WELL API NO. 30-025-04861
5. Indicate Type of Lease STATE ☐ FEE ☒ Fee Surface; Federal Minerals
6. State Oil & Gas Lease No.
7. Lease Name or Unit Agreement Name ATHA
8. Well Number 1
9. OGRID Number 19797
10. Pool name or Wildcat SWD; Seven Rivers-Queen (96132)

Key Energy Services, LLC proposes to plug and abandon the ATHA Well No. 1 in the following manner:

**Proposed Plugging Procedure
(Option 2 Shown)**

Key Energy Services, LLC

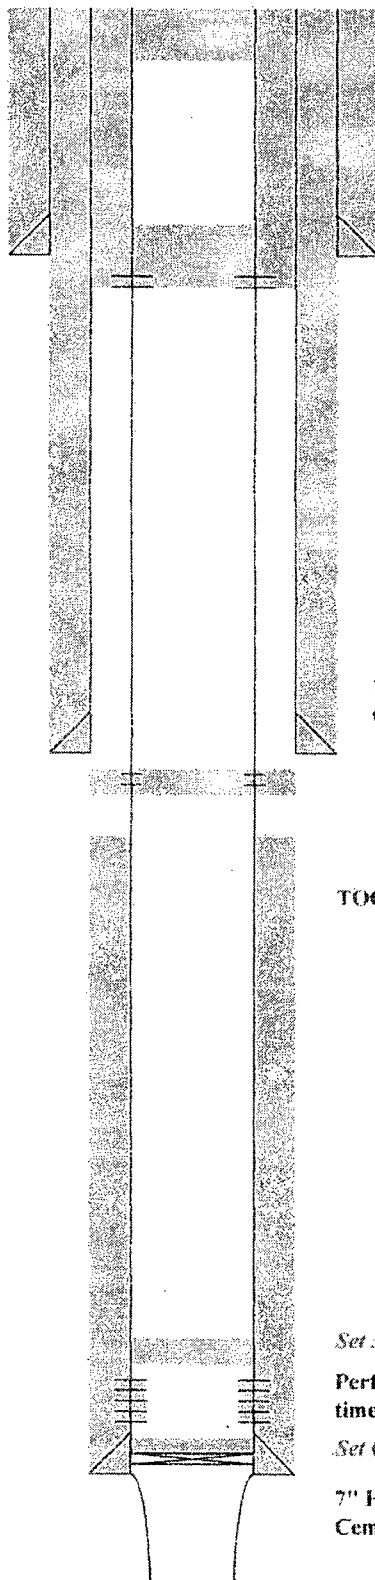
CIRC MLF.
Set CIBP @ 3,700' and cap with 35' of cement
Set 30 sx. cement plug 3,370'-3,470'
SPOT 45 SX 6 CMT 3700' - 3300' WOC & TAG. PRESSURE TEST CSG.
EST. RATE. IF UNABLE TO CIRC. GO TO OPTION #2
Option 1: Perforate 5 1/2" casing @ 1,775' & circulate cement to surface in the 5 1/2" x 7 5/8" annulus w/130 sx. cement. Leave plug in 5 1/2" casing 1,675'-1,775'. Set 30 sx. cement plug 460'-560'. Set 60" cement plug @ surface.
Option 2: Perforate 5 1/2" csg. @ 1,775' & squeeze 30 sx. cement plug 1,675'-1,775'. Perforate 5 1/2" casing @ 560' and circulate cement to surface in the 5 1/2" x 7 5/8" annulus w/70 sx. Leave cement plug in 5 1/2" casing 460'-560'. Set 60" cement plug @ surface.
INSIDE FOOT TO SURFACE. CUT OFF WELLHEAD. VERIFY CMT TO SURF. ALL CSG STRINGS.
Remove anchors & clean location.
